Sydney Metro Martin Place

North Tower Base Building Changes

SSD/ MOD drawings & FC2 Comparison

Rev #02 – 26/10/21

Level 24 Plan

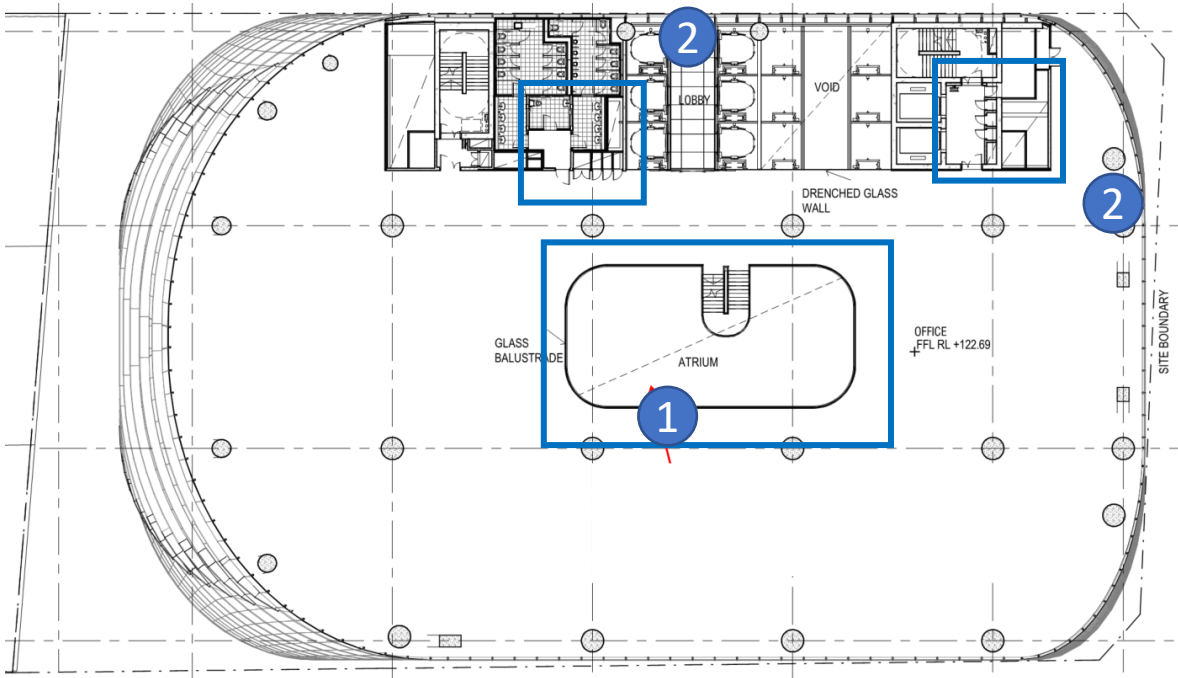
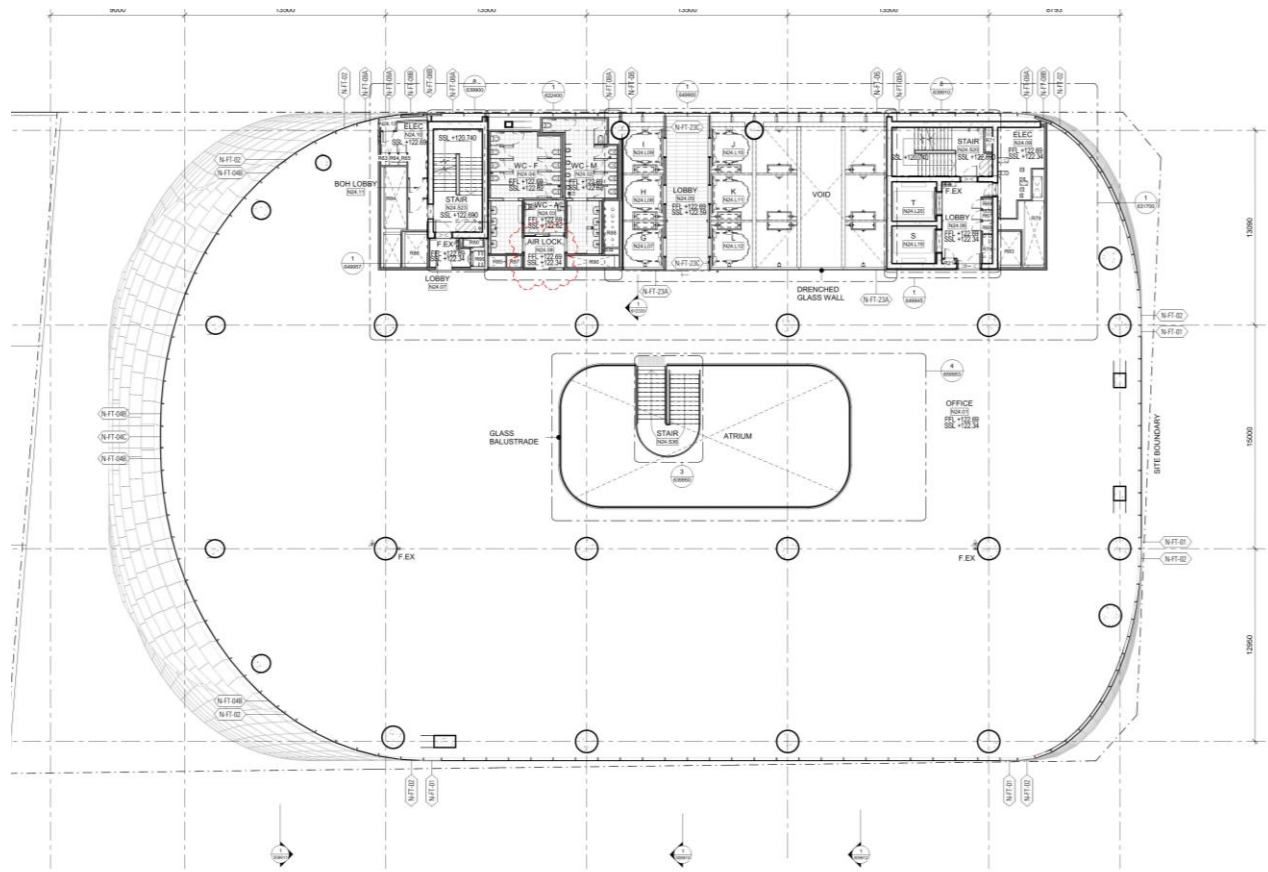
- 1.Atrium and stair revised
- 2.BOH layout revised

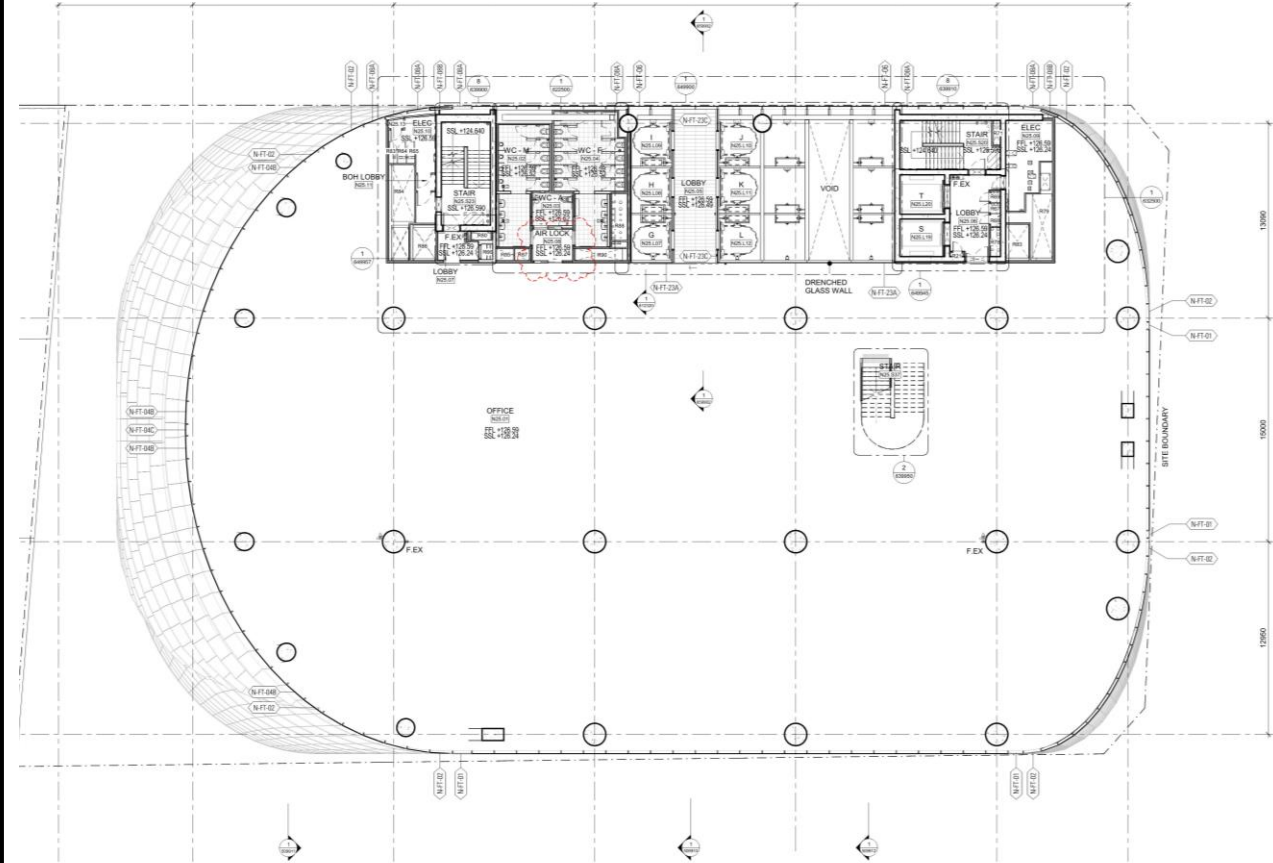
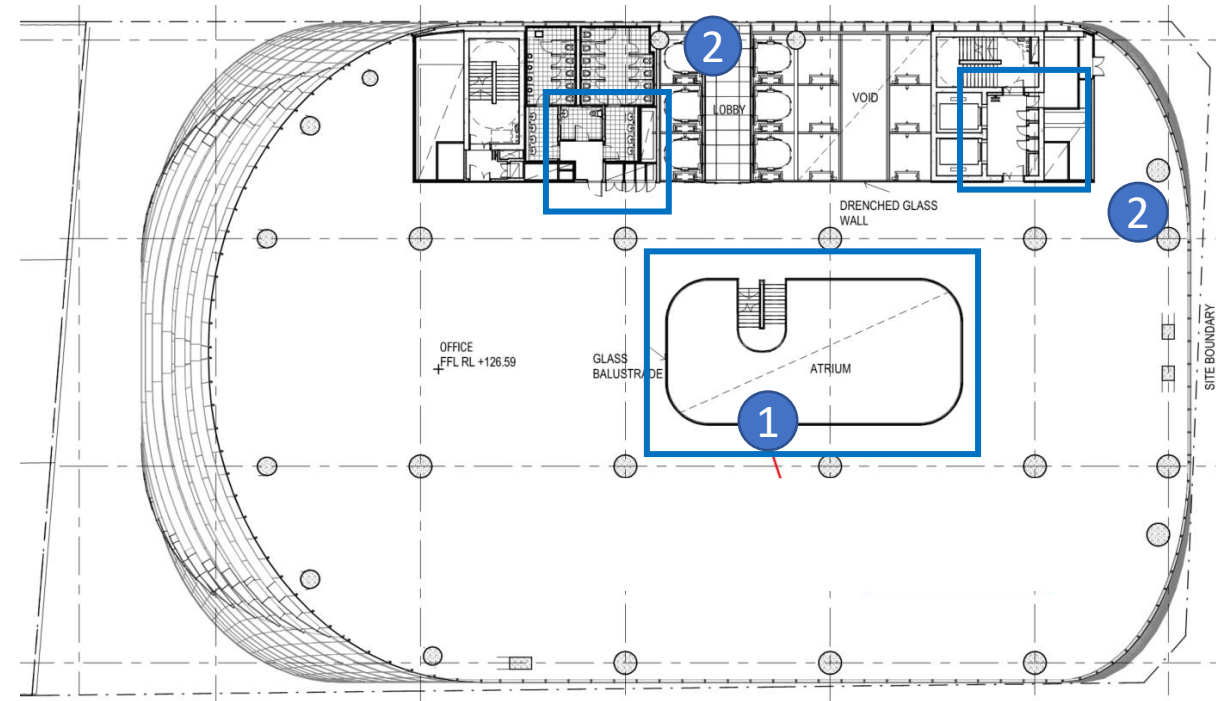
- 1.Atrium and stair revised
- 2.BOH layout revised

Level 27 Plan

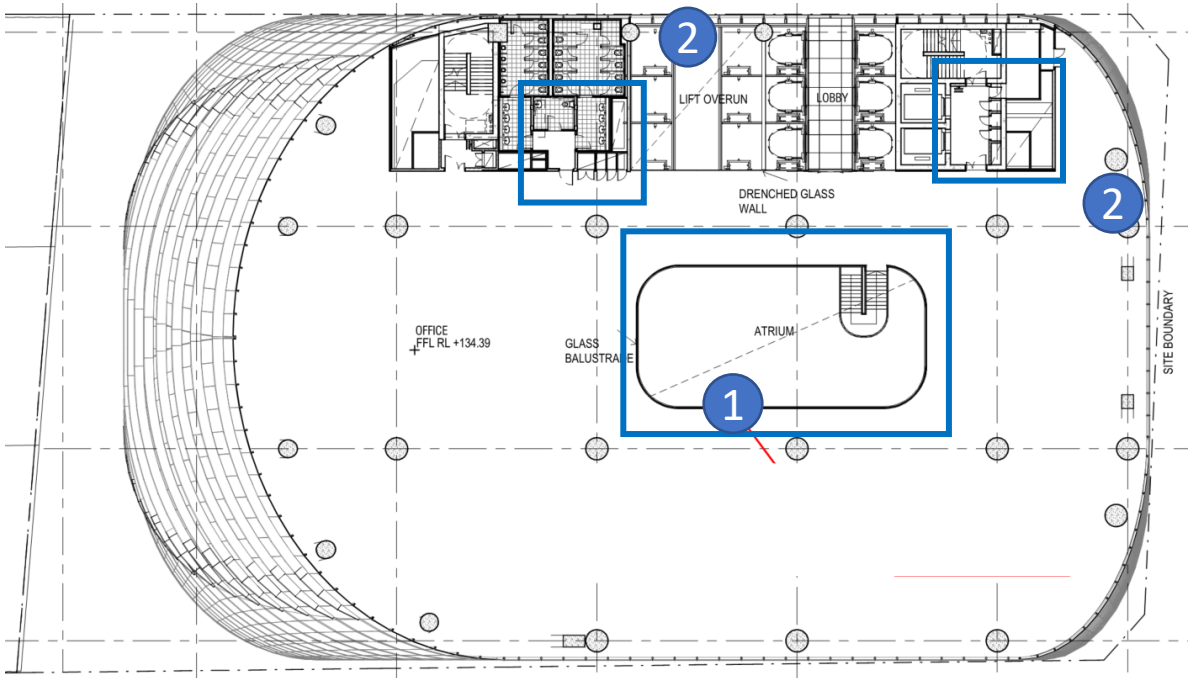
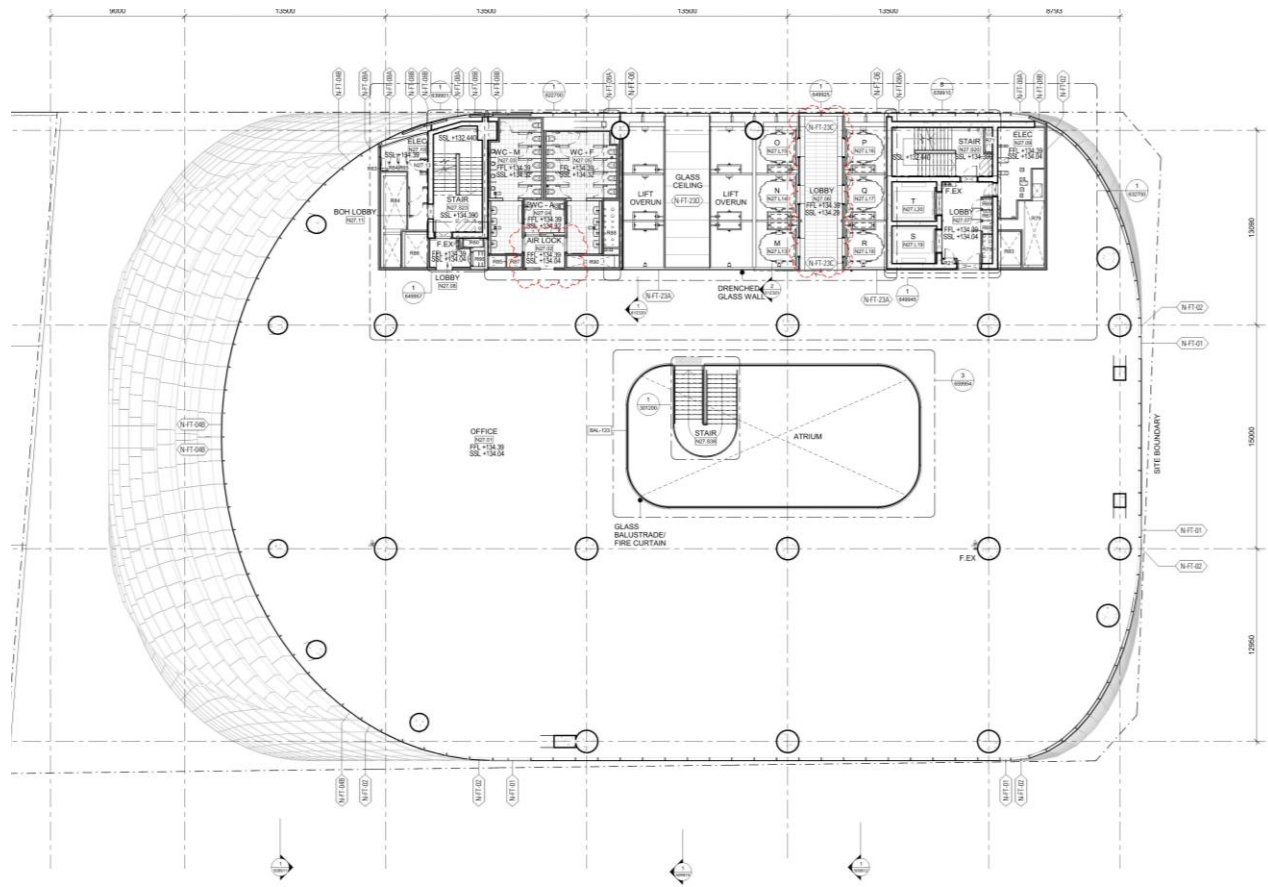
- 1.Atrium and stair revised
- 2.BOH layout revised

Level 28 Plan

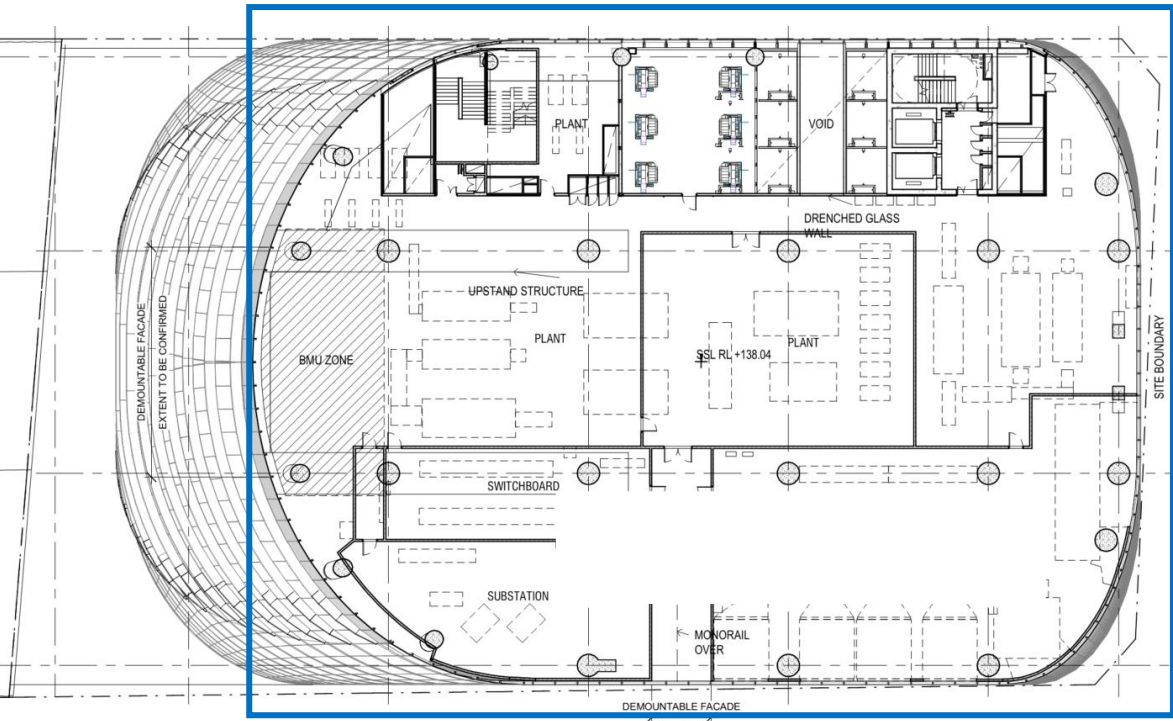
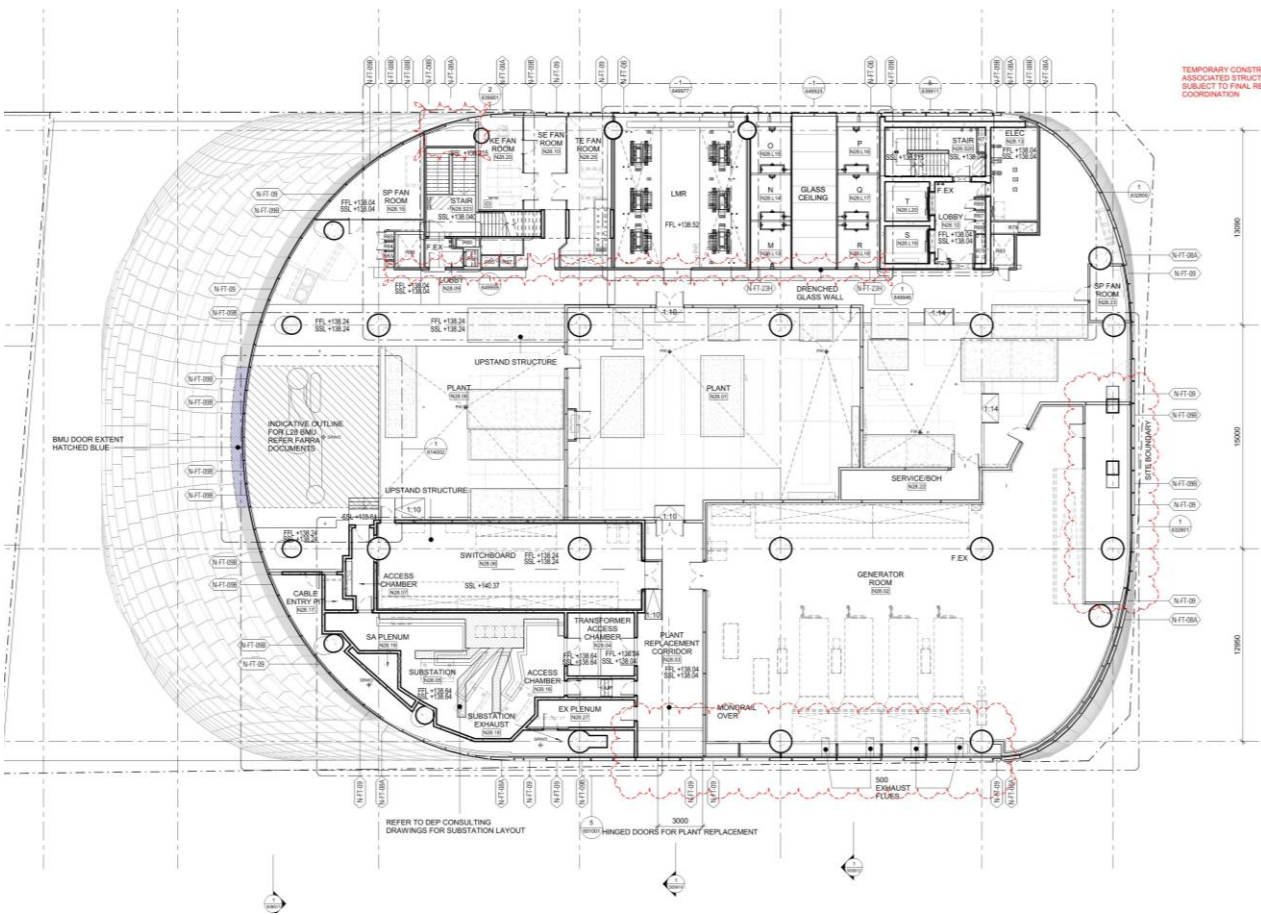
1.Plantroom layout revised

Level 29 Plan

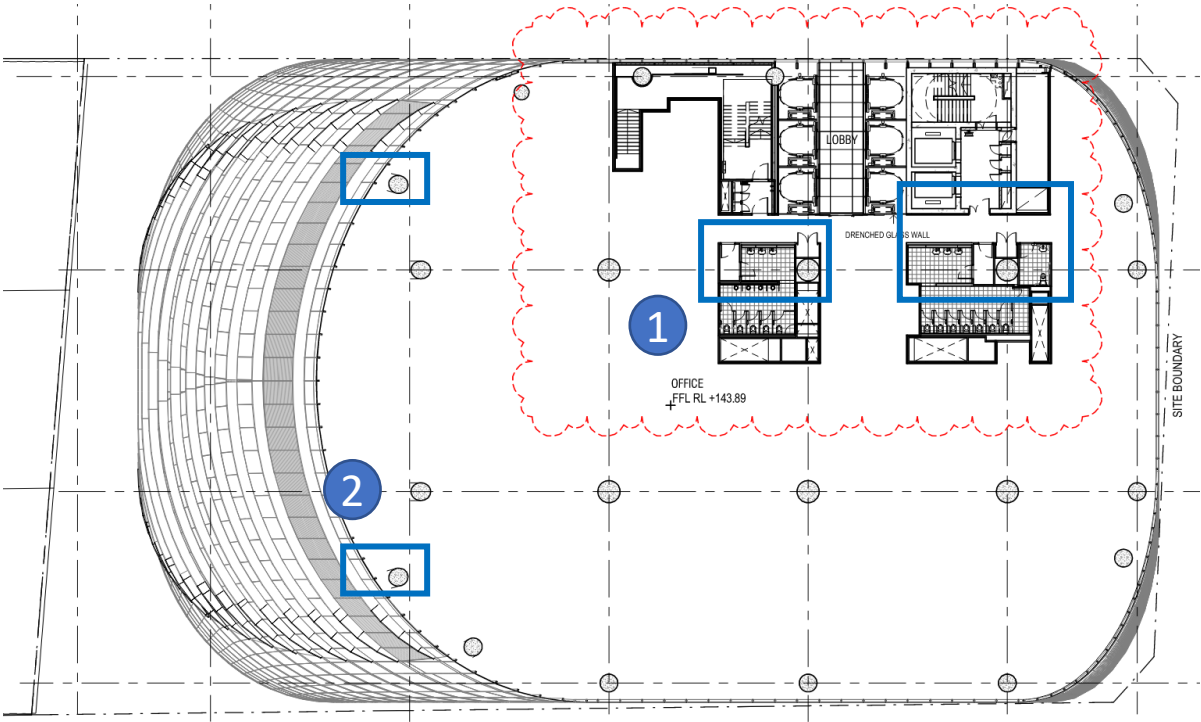
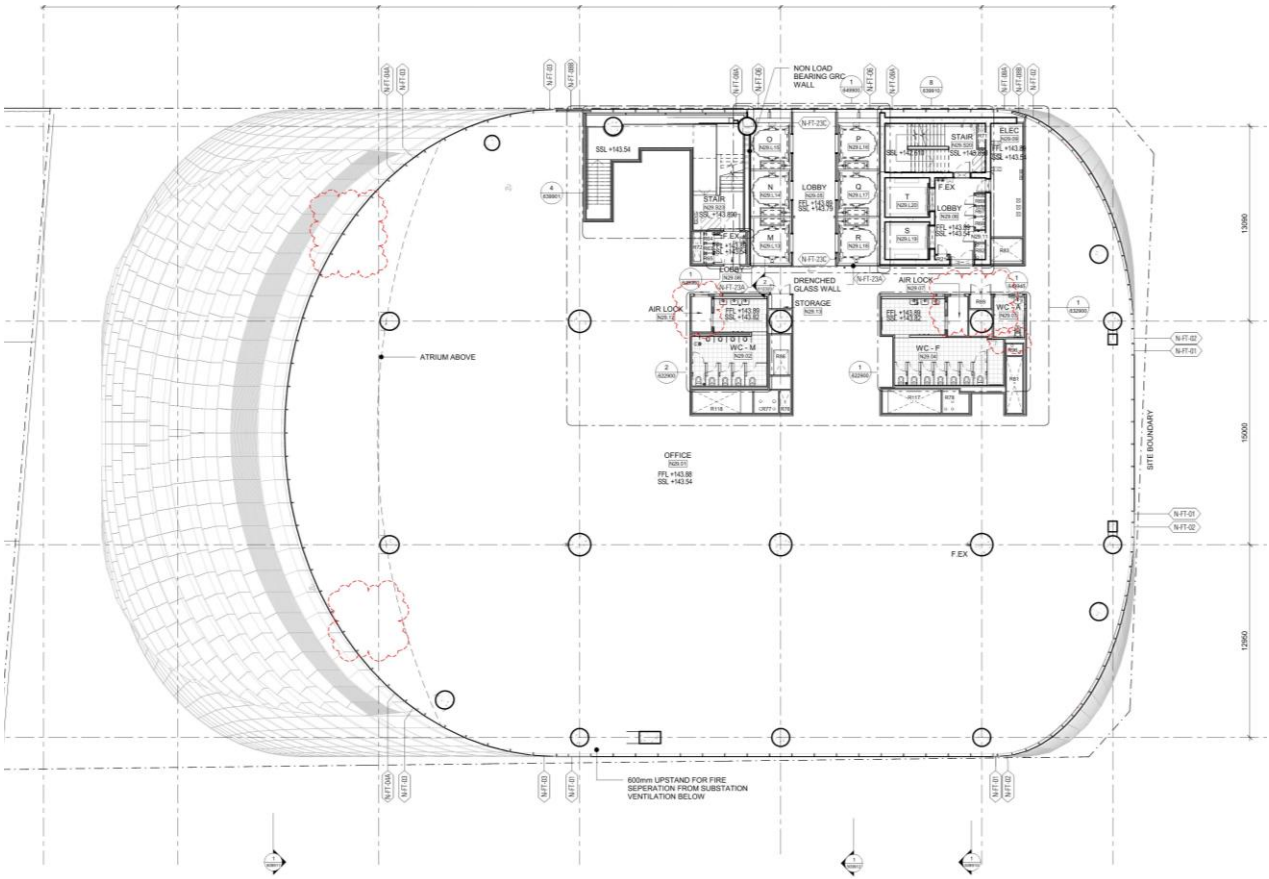
- 1. BOH layout revised
- 2. Columns deleted
